Honeycutt Creek Greenway

Summerfield North's Response

Raleigh Parks and Recreation 60% Design Proposal

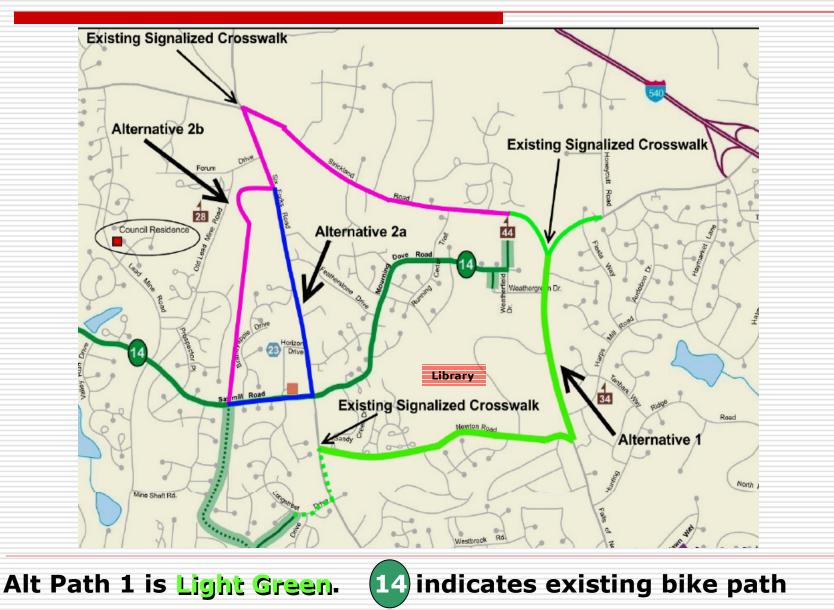
- No light or crosswalk.
- Traffic flows at 50 to 60 mph. (Posted speed limit 45)
- This is a 5 lane road (Center Turn/Suicide Lane).
- Homeowner's backing out of driveway run a much higher risk of hitting Greenway users due to wider path.
- Grade generally not to exceed 8%
- Old Deer Trail Crossing (see photos on page 9-11)

- The map on page 4 calls for the installation of:
 - 4 culverts
 - 2 bridges/boardwalks
 - 1 boardwalk
 - 7 minor crosswalks
 - Signs to mark the Greenway path.
 - Widening of the existing sidewalks to 10'.

Additional costs will be incurred to correct multiple grade issues at Old Deer Trail Crossing if addressed.
